Access Compliance Report

Public Rights-of-Way

(Curb Ramps)

Intersection ID: 26673	Main Street: APPLE_TWIG_DR	Cross Street: WINTHROP_RIDGE_RD	Location: W
ADA ID: 3D553F5022DD	Ramp Type: BlendTrans1	Initial Pass/Fail: Fail	Overall Compliance: No
Severity Score: 8.75			
Codes/Mitigation Info/Possible Solution		Field Measurements/Component Compliance

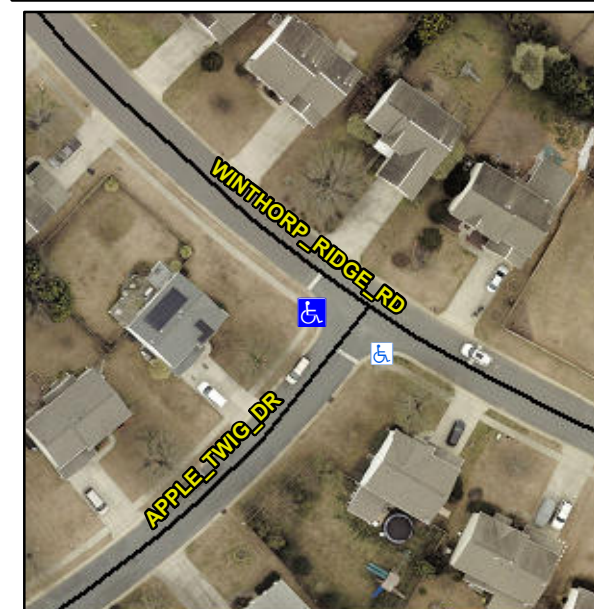
Compliance	Description	Data	Compliance	Description	Data
N/A	Ramp Length (in)	50.0	Yes	BlendTrans Slope (%)	2.1
No	Ramp Width (in)	45.0	Yes	BlendTrans XSlope (%)	0.0
N/A	Flare Type LT	N/A	N/A	Flare Type RT	N/A
N/A	Flare Slope LT (%)	N/A	N/A	Flare Slope RT (%)	N/A
N/A	Flare Traversable LT?	N/A	N/A	Flare Traversable RT?	N/A
N/A	Landing Length (in)	N/A	N/A	DWS Provided?	N/A
N/A	Landing Width (in)	N/A	N/A	DWS Contrast?	N/A
N/A	Landing Slope (%)	N/A	N/A	DWS Length (in)	N/A
N/A	Landing X Slope (%)	N/A	N/A	DWS Full Width?	N/A
N/A	Landing Curb? (Y/N)	N/A	N/A	DWS Offset (in)	N/A
N/A	Shared Landing?	N/A			
N/A	Gutter Ponding?	N/A	N/A	Gutter Slope (%)	N/A
N/A	Gutter Lip Ht (in)	N/A	N/A	Gutter X Slope (%)	N/A
N/A	Painted X Walk1?	No	N/A	Painted X Walk2?	No
	X Walk 1 Direction	To SE		X Walk 2 Direction	To NE
	X Walk 1 Width (in)	N/A		X Walk 2 Width (in)	N/A
	X Walk 1 Slope (%)	1.9		X Walk 2 Slope (%)	1.2
	X Walk 1 X Slope (%)	0.3		X Walk 2 X Slope (%)	2.1

N/A	Ramp inside XWalk1?	N/A	N/A	Ramp inside XWalk2?	N/A
	Road Slope (%)	0.8		Clear Space?	N/A
	Road X Slope (%)	3.9	N/A	Clear Space to XWalk (in)	N/A
N/A	Any Obstructions?	N/A	N/A	Storm Grate/Utility Hazard?	N/A
	Obstruction Type			Storm Grate/Utility Type	
		N/A			N/A
			Yes	Surface Condition? (G/P)	Good
			N/A	Curb Slope (%)	N/A

Remove & Replace Curb Ramp With Two New Directional Ramps or Equivalent.

R304.5.1
